Smart Motorways Programme

M4 J3 - J12

Acoustic Barrier Changes
Technical Note

Document Number: HA514451-CHHJ-HFE-S1_ZZZZZZZZ_Z-TN-KK-0001

Figure 2 Increase in ground floor noise levels without proposed 2-metre-high barrier

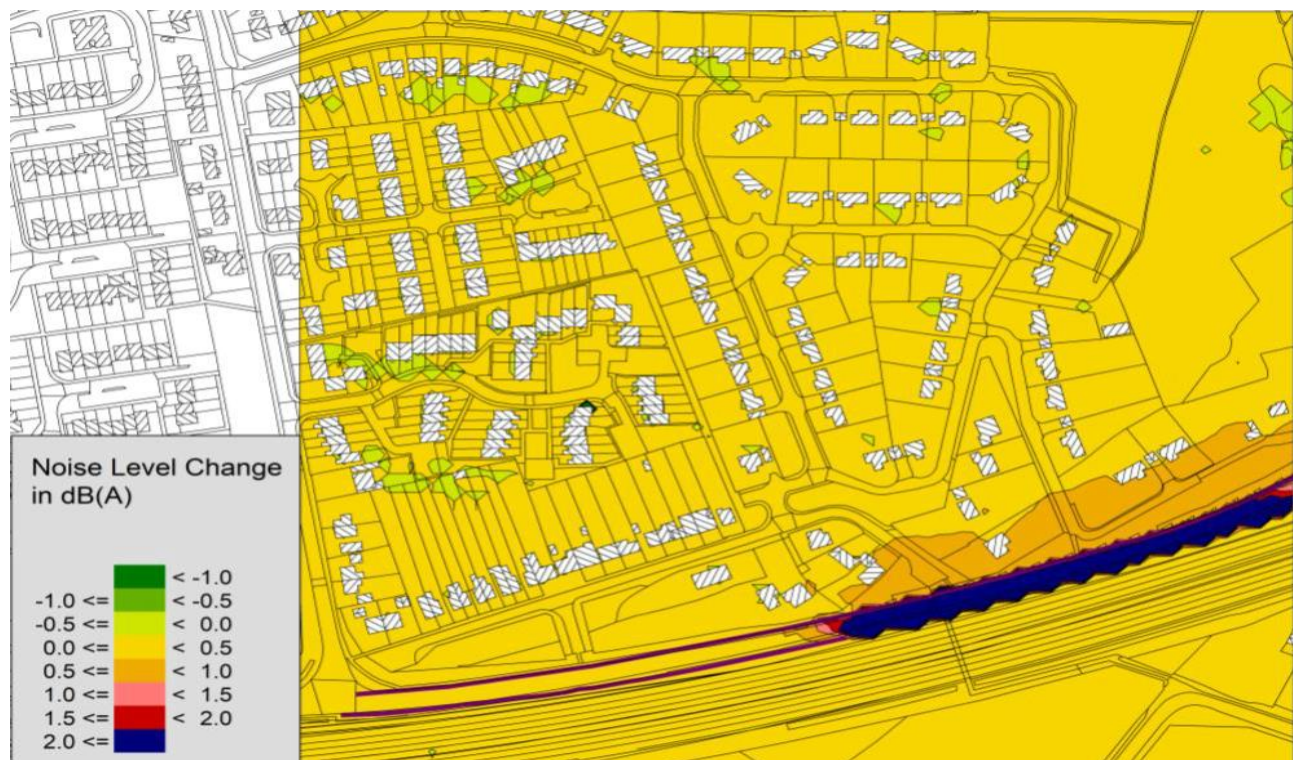
This location has been remodelled and noise level contours at ground floor height and at first floor height calculated for the following with-scheme scenarios:

- 1) With existing 3 metres high noise barrier and existing barrier in the eastbound verge
- 2) With existing 3 metres high noise barrier, existing barrier in the eastbound verge and proposed 2 metres high noise barrier to motorway (Ch. 53650 – Ch. 53902)

Figure 2 below shows the increase in noise levels at ground floor height without the proposed 2 metres high noise barrier - scenario 1) minus scenario 2).

Figure 2 show that the noise increases at ground floor level across the study area due to the removal of the 2 metres high noise barrier are negligible (< 1 dB).

It is concluded that the proposed 2 metres high noise barrier to the motorway would not provide any significant noise reductions and would not be value for money. Consequently, EM6 can be removed from the new noise barrier provision for the Scheme without changing the conclusions of the assessment presented in the Environmental Statement.

Figure 3 Increase in first floor noise levels without proposed 2-metre-high barrier

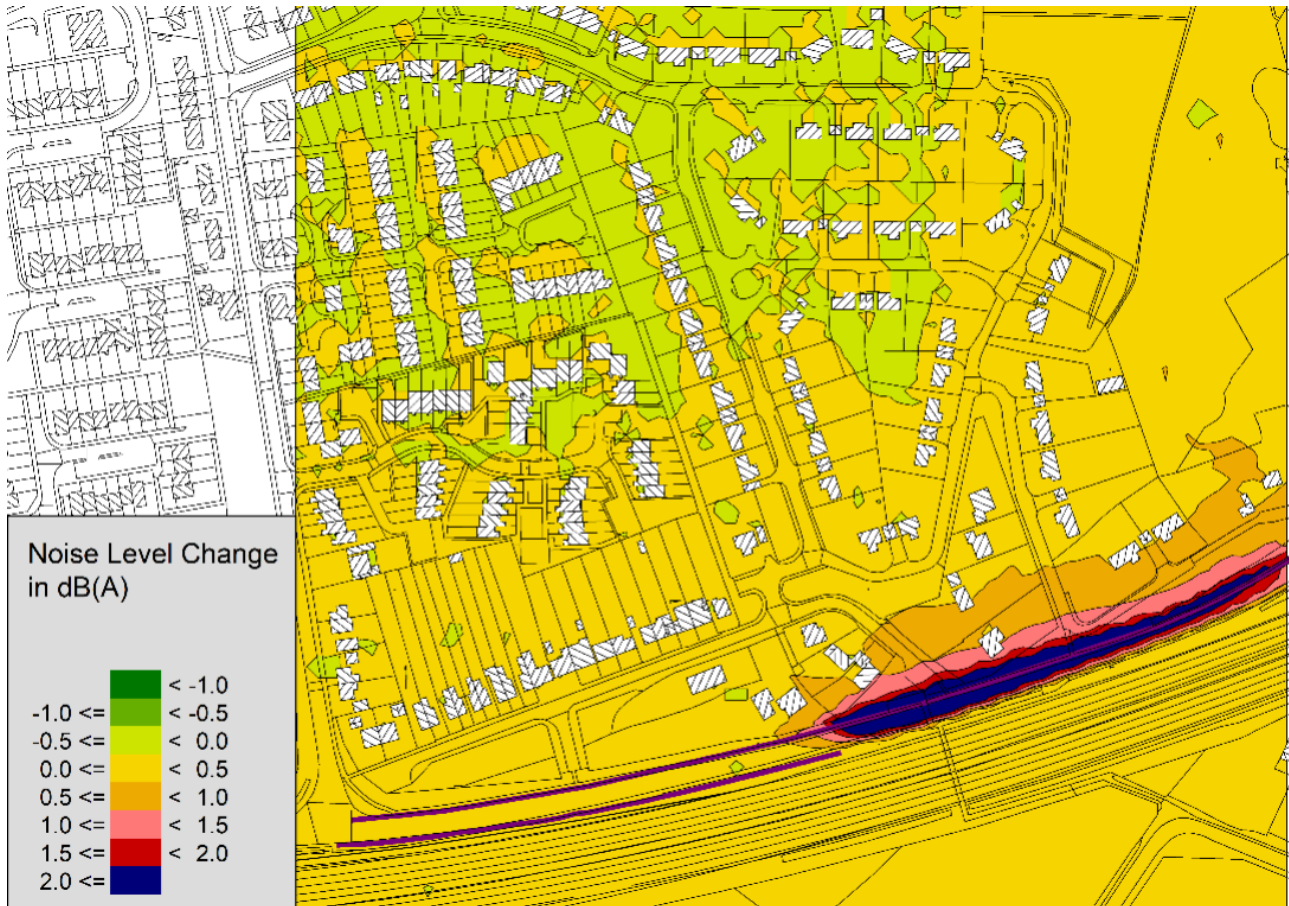
Figure 3 below shows the increase in noise levels at first floor height without the proposed 2 metres high noise barrier - scenario 1) minus scenario 2).

Figure 3 shows that the noise increases at first floor level across the study area due to the removal of the 2 metres high noise barrier are negligible (< 1 dB), apart from 2 receptors where the increases are 1.1 dB(A) and 1.3 dB(A), which are at the bottom end of the Minor impact range. However, these 2 receptors would still experience negligible noise reductions at first floor level when comparing the with-scheme scenario to the without-scheme scenario.
